Supplemental Council Agenda Report

Subject: Appeal of Planning Commission Resolution No. 24-39 Regarding Coastal Development Permit No. 23-004 (29738 Cuthbert Road, APN 4469-041-011, Owner Malibo LLC, Appellant Charlotte Frieze Jones, for Malibu Park Neighbors Group)

Applicant Response to Appeal

Project: 29738 Cuthbert Road - PVWF 21-034 & CDP 23-004

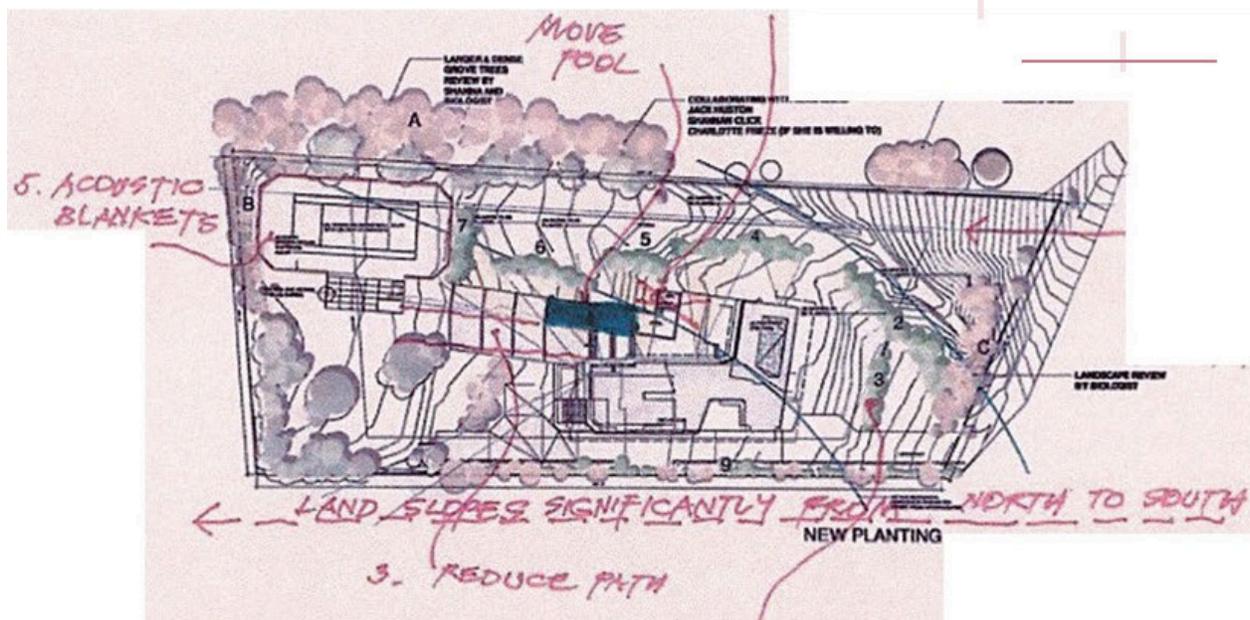
Add a condition, if needed, an underground stormwater detention basin will be installed.

We will abide by the required code and city standards.
